STEAM GENERATOR WATER HAMMER EVALUATION  
H. B. ROBINSON STEAM ELECTRIC PLANT UNIT NO. 2

U. S. Nuclear Regulatory Commission  
Washington, D. C. 20555

Report No. 6-2

March 13, 1980

Figure 6. J-tubes Similar to those used at Indian Point Unit 2. [2]

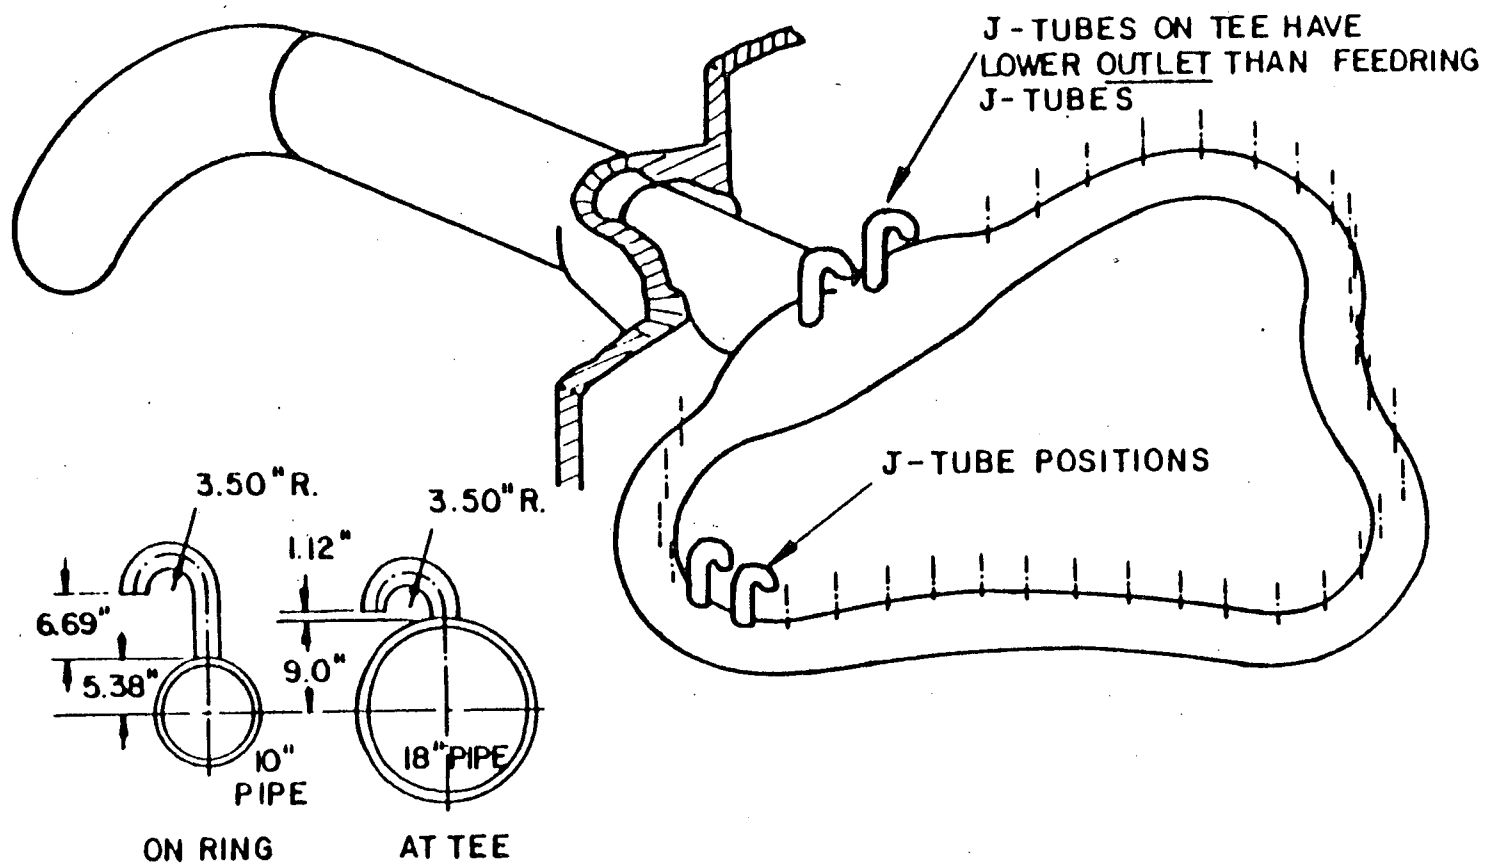
In the interest of helping to keep the feedring from draining it has been recommended in the Creare Report [2] to install "J-tubes" similar to those shown in Figure 6. Currently, HBR does not plan to do this because of other mitigating features of the plant and the absence of any damaging hammer in the plant history [4].

Figure 7. HBR Feeding and Piping Sketch

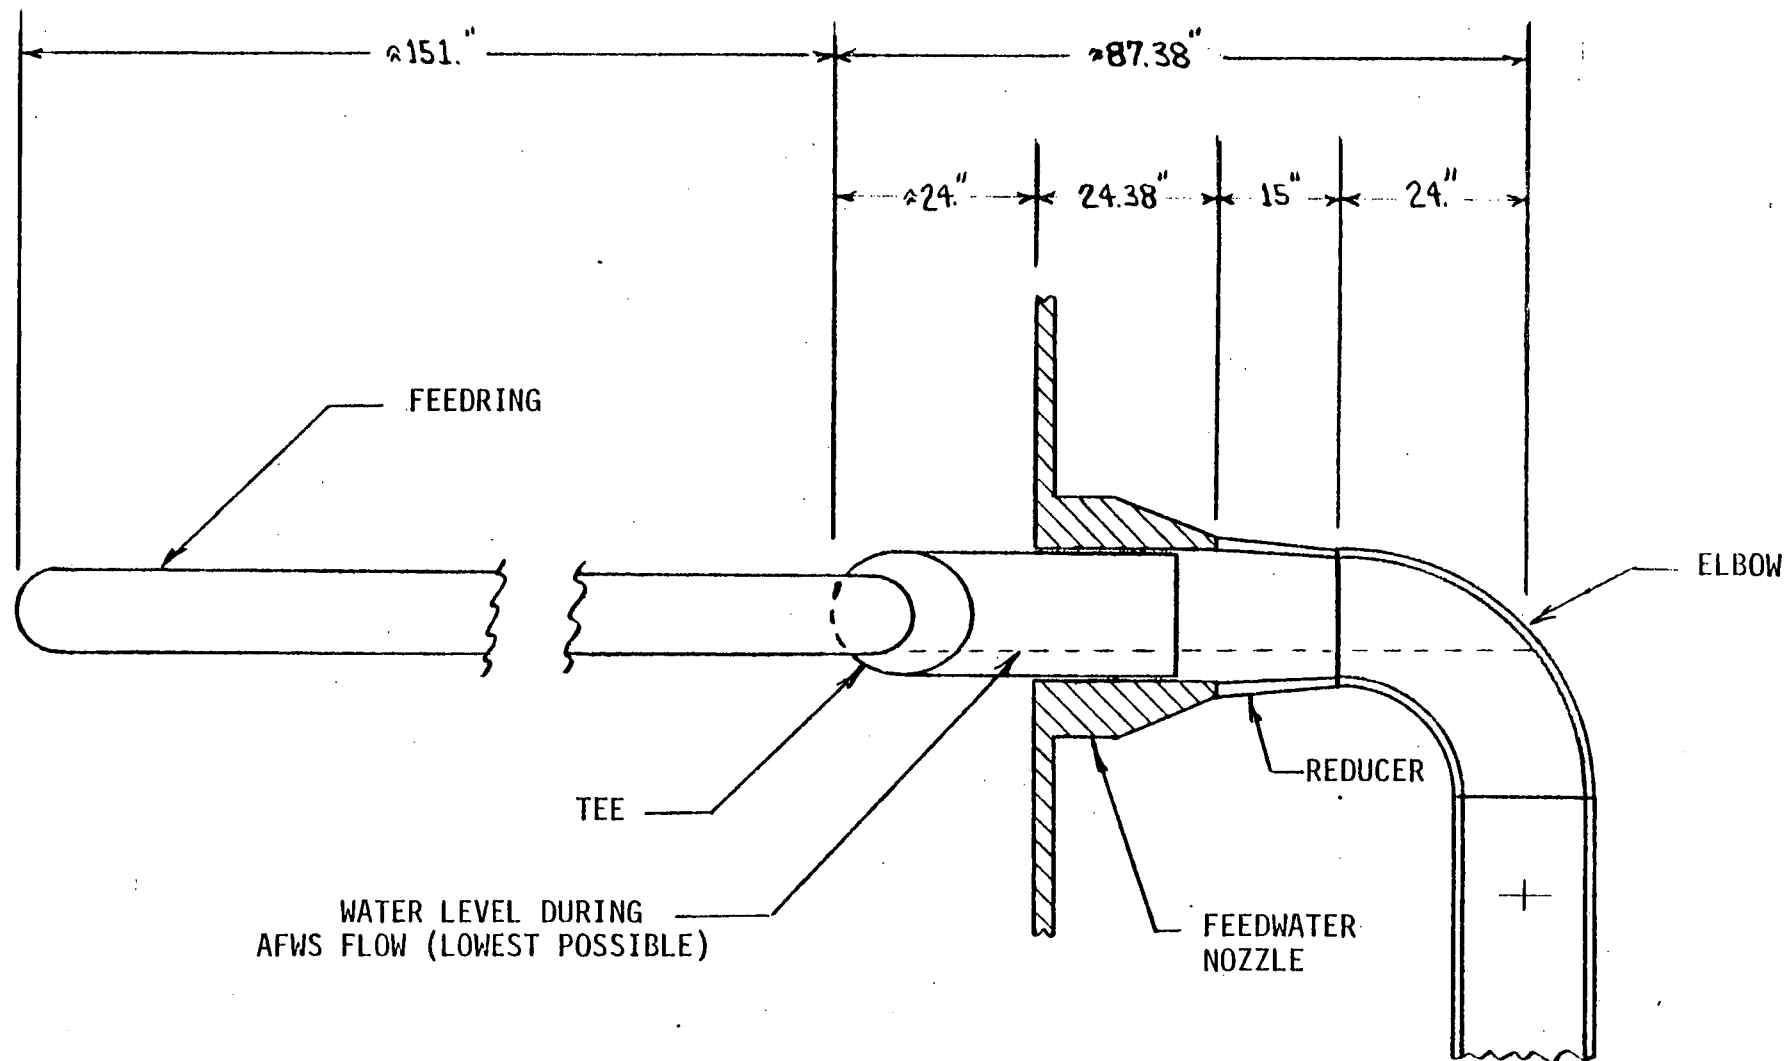
In the Creare Report [2] mention is made of adding the length of the feedring itself to the total "horizontal" run of drainable pipe when considering the water hammer potential. We have concluded that this is not correct. Steam void collapse (should any occur in the feedring) would accelerate a slug of water to produce only internal momentum transfer. While external pressure pulses could occur they would be much less than those generated by a water hammer in an external feedwater pipe section. Also, no known damage has been traced to water hammers originating in the feedring sparger.

The model test results reported do not show a reduced likelihood of water hammer occurrence with decreasing external piping horizontal length. However, the over-pressure did decrease. Also, these model tests did not accurately simulate the feedring geometry. A simple straight pipe was used to model the feedring which allowed its total length to act as a direct extension of the external "horizontal" piping. Thus, it can be seen how in this case the simulated feedring length contributed to the mechanisms initiating water hammer and allowed a direct linear communication between feedring and external piping facilitating momentum transfer.
